SHDC
Planning & Development
19 MAR 2008
Ref. 0358/08

Client	MR & MRS HENDY
Project	TYSDALE HOUSE BARNS
Drawing title	HOLIDAY ACCOMMODATION
Job No	812/1
Drawing No	SK 02
Rev	
Drawn	GJ
Scale	1:1250. 1:500. 1:100
Date	09/07
Checked

PROPOSALS

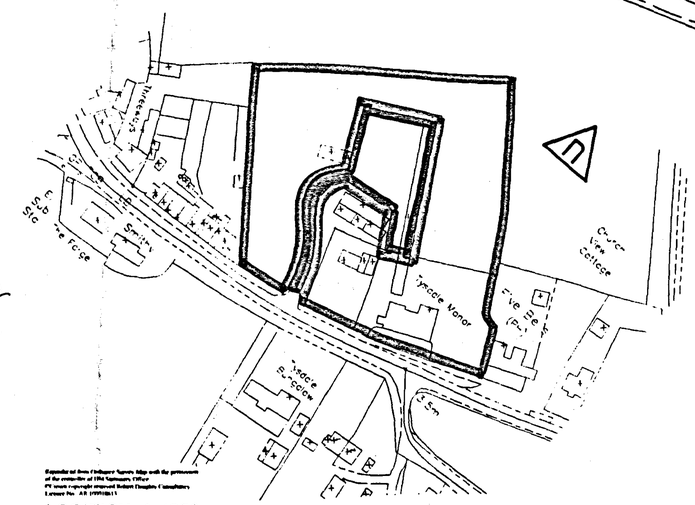
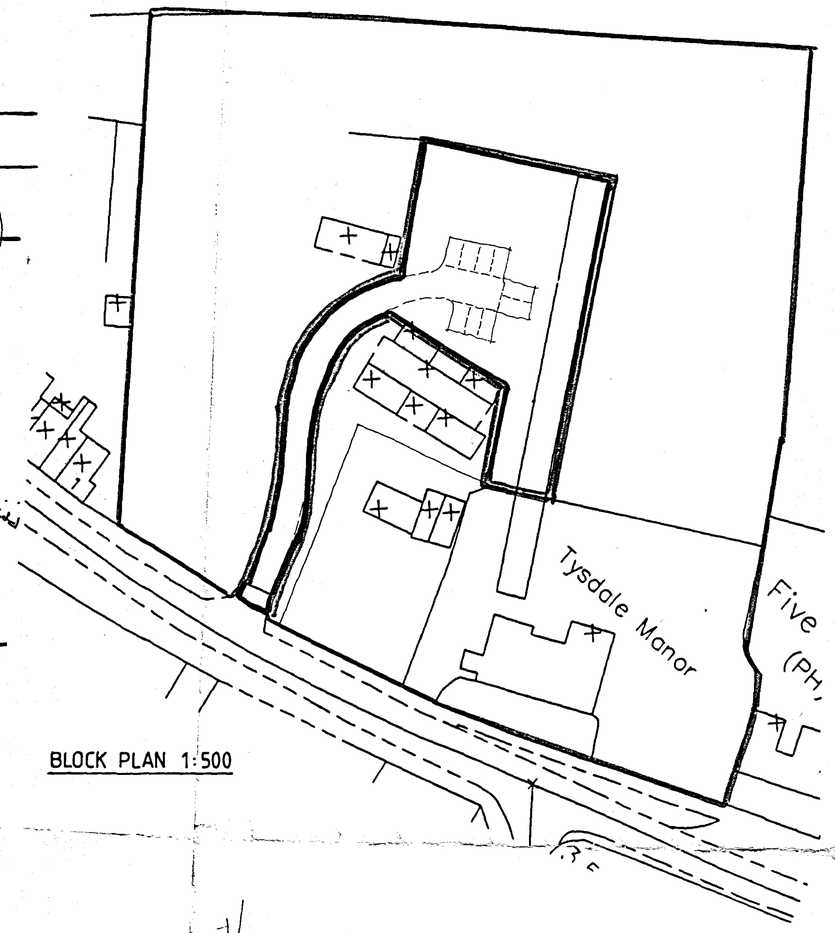
appears contrary to engineers report with studies floor to be put in.

not able to access to see if subdivision is appropriate - but after SV am not convinced it is a good idea.

What happens to historic fabric here? Doesn't appear at all appropriate. The line of the wall proposed falls outside the historic boundary + retained floor - this relationship
